BUREAU OF INDIAN STANDARDS

MINUTES

23 rd Meeting of Water Conductor Systems Sectional Committee, WRD 14		
Day and Date	Time	Venue :
Monday, 03 rd June 2024	From 10:30 A.M.	Hybrid Venue at Committee Room (R-625), 6 th Floor, Sewa Bhawan.
Chairperson: SHRI VIJAI SARAN, CHIEF ENGINEER, DESIGN (NW&S), CWC		Member Secretary: SHRI NAVDEEP YADAV, ASSISTANT DIRECTOR, WRD, BIS

Figure 1 Typical swirl meter

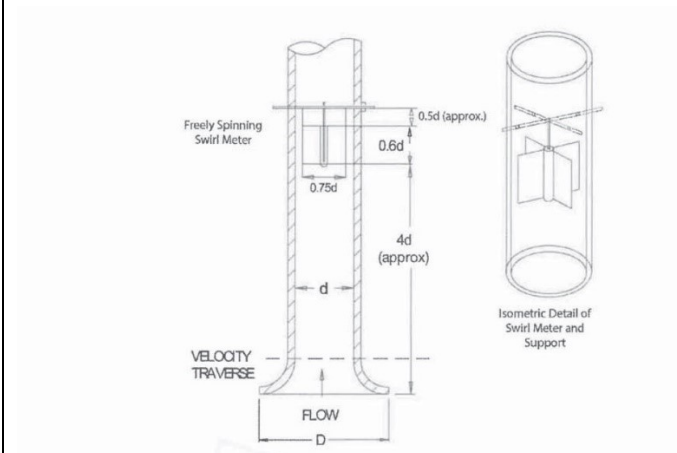
<p>6.</p>	<p>Prof. Z Ahmed, IIT Roorkee</p>	<p>Fig. 2</p>	<p>-do-</p>	<p>Deletion of old figure and insertion of new figure</p>	<p>Vortex Type</p> <p>Surface swirl</p> <p>1</p> <p>Vortex Type</p> <p>2</p> <p>Surface swirl</p> <p>3</p> <p>Dye core to intake: coherent swirl throughout liquid column</p> <p>4</p> <p>Vortex with trash</p> <p>5</p> <p>Vortex pulling air bubbles to intake</p> <p>6</p> <p>Vortex with fuel</p> <p>A. Free surface vortices</p> <p>1 Swirl</p> <p>2 Dye core</p> <p>3</p> <p>B. Subsurface vortices</p>	<p>Panel members deliberated and decided to discuss the comment in the next Committee meeting.</p>	<p>The Committee deliberated and requested Prof. Z Ahmed, IIT Roorkee to share definitions of all types of vortex given in the figure and requested the panel group to discuss and submit their final view.</p>
<p>7.</p>	<p>Prof. Z Ahmed, IIT</p>	<p>Item 5</p>	<p>-do-</p>	<p>Insertion of New clause 5</p>	<p>5.0 Physical model studies of Pump Sump</p> <p>5.1 Need for a physical model study</p>	<p>Panel members deliberated and decided to discuss the comment</p>	<p>The Committee noted that the inputs shared by Prof. Z Ahmed are</p>

Swirl in the suction pipe: The intensity of flow rotation shall be measured using a swirl meter, see Figure 1. The swirl meter shall consist of a straight-vaned propeller with four vanes mounted on a shaft with low-friction bearings. The tip-to-tip vane diameter is 75% of the pipe diameter and the vane length (in the flow direction) is equal to 0.6 pipe diameters. The location of the swirl meter should be about four suction pipe diameters downstream from the bell or pump suction flange to allow for convenient installation of velocity traverse instrumentation. The revolutions per unit time of the swirl meter are used to calculate a swirl angle, θ , which is indicative of the intensity of flow rotation.

Rook ee			<p>A properly conducted physical model study is a reliable method to identify unacceptable flow patterns at the pump suction for given sump or suction piping design and to derive acceptable intake sump or piping designs. Considering the cost for a physical model study, an evaluation is needed to determine if one is required. A physical hydraulic model study shall be conducted for pump intakes with one or more of the following features:</p> <ul style="list-style-type: none"> • A suction intake arrangement with elevation relative to water level that does not provide the minimum submergence requirement of this standard, irrespective of pump manufacturer's stated submergence values. • The intake design is not a standard intake design presented in this standard or the geometry (such as bay width, bell clearances, sidewall angles, bottom slopes, distance from obstructions, the bell diameter, submergence, or piping changes, etc.) deviates from this standard. • There is no prior physical model study for the intake design considered in terms of physical features and flow rates. • Non-uniform or non-symmetric approach flow to the pump sump exists (e.g., intake from a significant cross-flow, use of dual flow or drum screens; use of elbows, bends, or multiple screens just upstream of a trench-type wetwell; 	in the next Committee meeting	<p>very exhaustive and need to be streamlined for addition in the draft. The requirement of model study is already brought out in Cl. 5.0. Committee stressed that content in BIS code should be brief and not as detailed as in manual / guideline.</p> <p>Therefore, the Committee requested CWPRS to review the changes and submit their inputs to the panel group for discussion and finalisation.</p>
